# AIA Document G731™ – 2019

## Change Order, Construction Manager as Adviser Edition

Christian County High School

**RE:** Access Control System Modifications

Author's Project No: 2106-204  
Date: May, 20  
Drawing No: E2.1F

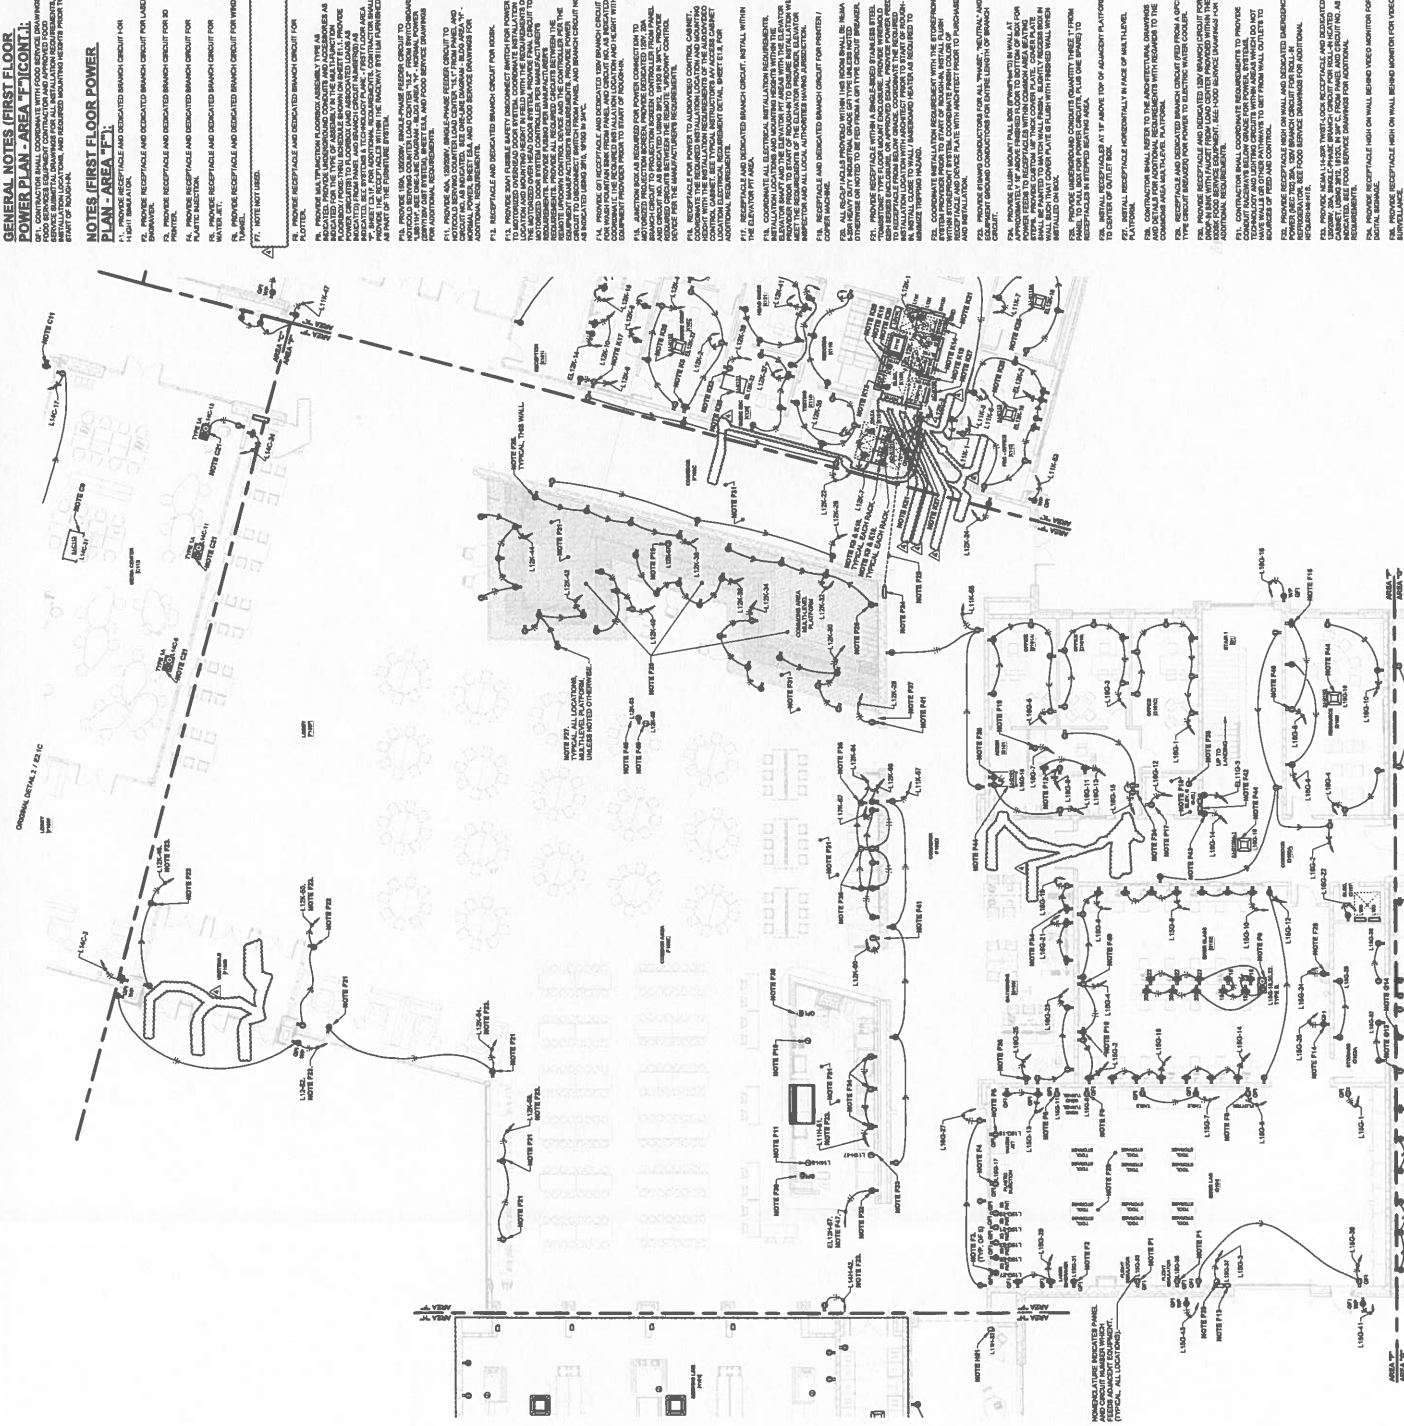
- b. Admin E101. DELETE requirement to provide 120V power circuit to Power supply for door hardware (Two doors).
9. Reference Revised Drawings E2.1F Rev 4, E6.9 Rev 3 & E6.14 Rev 1.

**E3.1H**

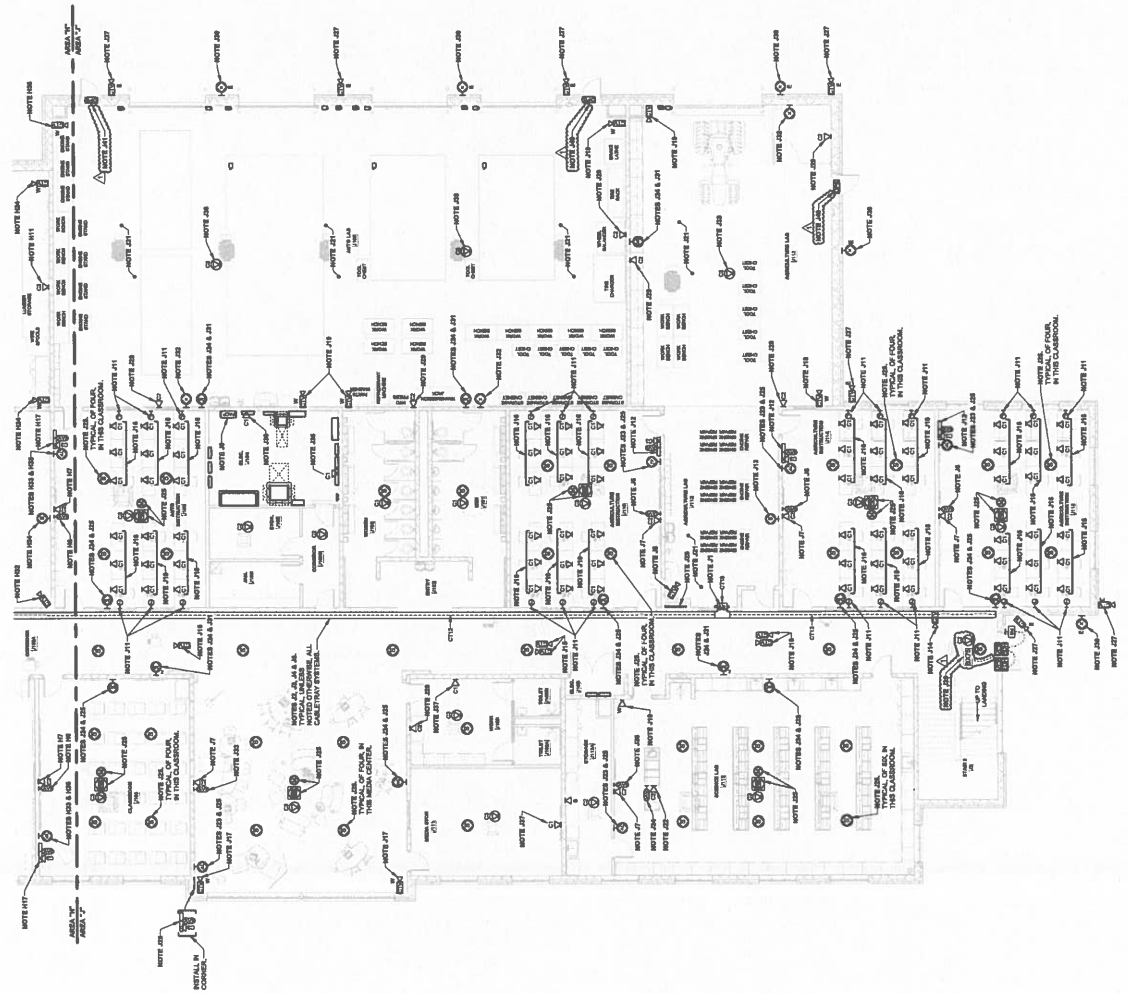
26. Reference Revised Drawing E3.1H Rev 1.

- d. Elec Room H114.
  - i. Door H114.2. **DELETE** requirement to provide composite low voltage cable from Access Control Panels in Data Room H190 to the door hardware access control system devices.

- ii. Doors H114.2. **ADD** requirement to provide low voltage access control system cables from the BX75 equipment [provided within the accessible ceiling cavity space of Corridor H100A] required to control & monitor the door.

- e. Elec Room H115.
  - i. Door H115.1. **DELETE** requirement to provide composite low voltage cable from Access Control Panels in Data Room H190 to the door hardware access control system devices.

- ii. Doors H115.1. **ADD** requirement to provide 22/4 low voltage cable from BX75 equipment [provided within the accessible ceiling cavity space of Corridor H100A] to the door position switch on the exterior door.

- f. Prep Room H105.
  - i. Exterior Door H105.5. **DELETE** requirement to provide composite low voltage cable from Access Control Panels in Data Room H190 to the door position switch on the exterior door.

- ii. Exterior Door H105.5. **ADD** requirement to provide 22/4 low voltage cable from BX75 equipment [provided within the accessible ceiling cavity space of Corridor H100A] to the door position switch on the exterior door.

- g. Mech Room H192.
  - i. Exterior Door H192.2. **DELETE** requirement to provide composite low voltage cable from Access Control Panels in Data Room H190 to the door position switches on the exterior door.

- ii. Exterior Door H192.2. **ADD** requirement to provide 22/4 low voltage cables from BX75 equipment [provided within the accessible ceiling cavity space of Corridor J100A] to the door position switches on the exterior doors.

Drawing No: E6.1

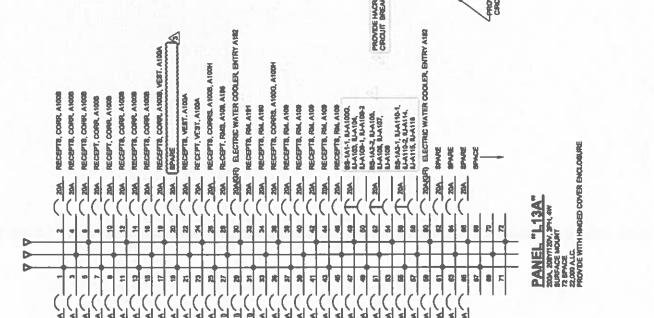
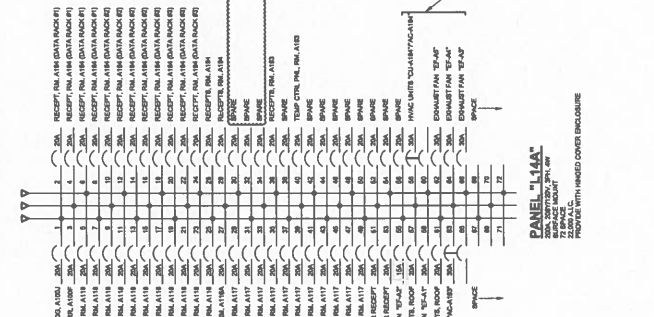
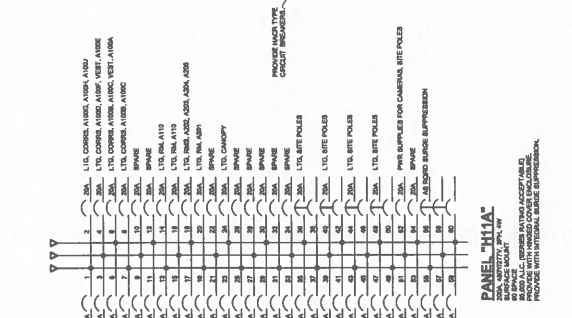
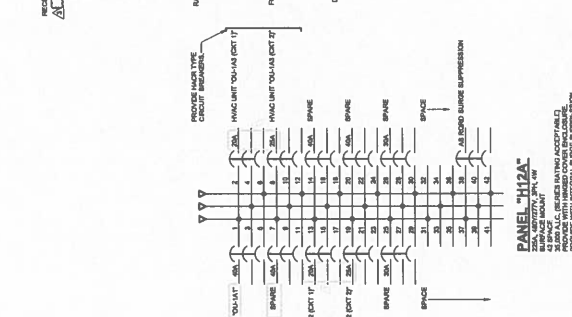
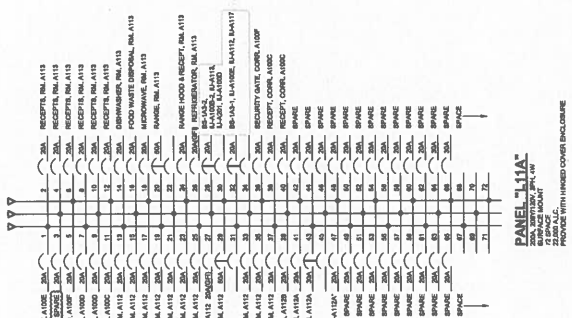
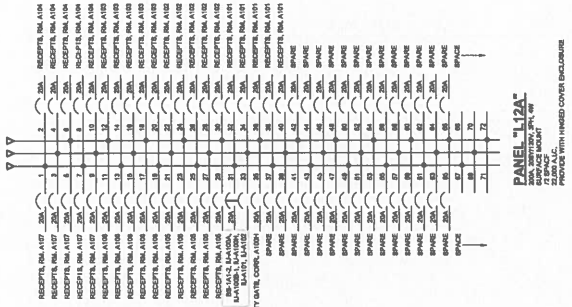
4. Reference Revised Drawings E2.1A Rev 3 & E6.1 Rev 3.
  - a. Vestibule A100A. ~~DELETE~~ requirement to provide 120V power circuit to Power supply for door hardware (Three doors).

Sheet Title: BUSSING DIAGRAMS - BLDG AREA 'D' (1ST FLOOR) - NORMAL POWER. Date: May, 20. Another's Project No: 2106-204. Drawing No: E6.4

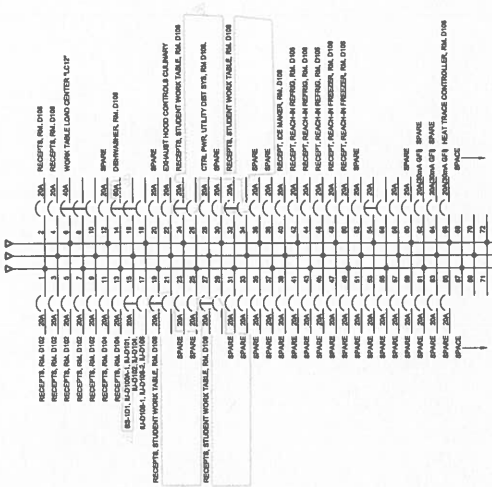
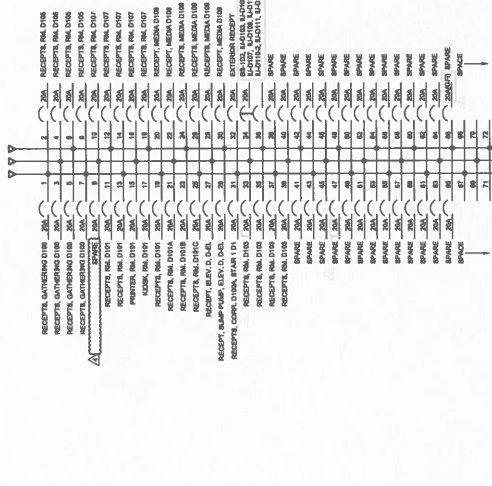
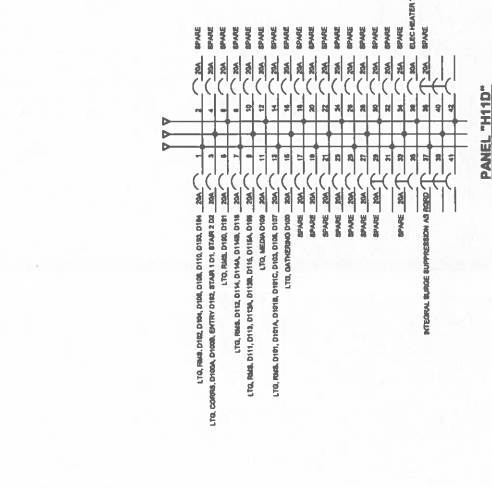
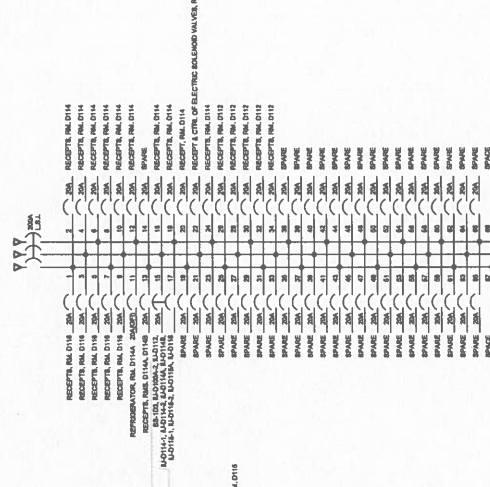
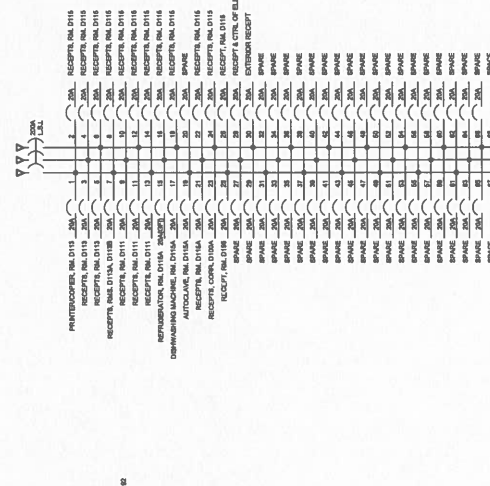
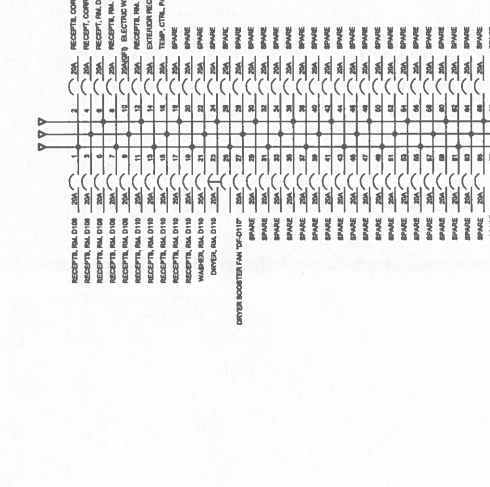
7. Reference Revised Drawings E2.1D Rev 3 & E6.4 Rev 4.
  - a. Corridor D100A. ~~DELETE~~ requirement to provide 120V power circuit to Power supply for door hardware (West End of corridor).

- b. Admin D101. ~~DELETE~~ requirement to provide 120V power circuit to Power supply for door hardware (Two doors).
8. Reference Revised Drawings E2.1E Rev 2 & E6.6 Rev 2.
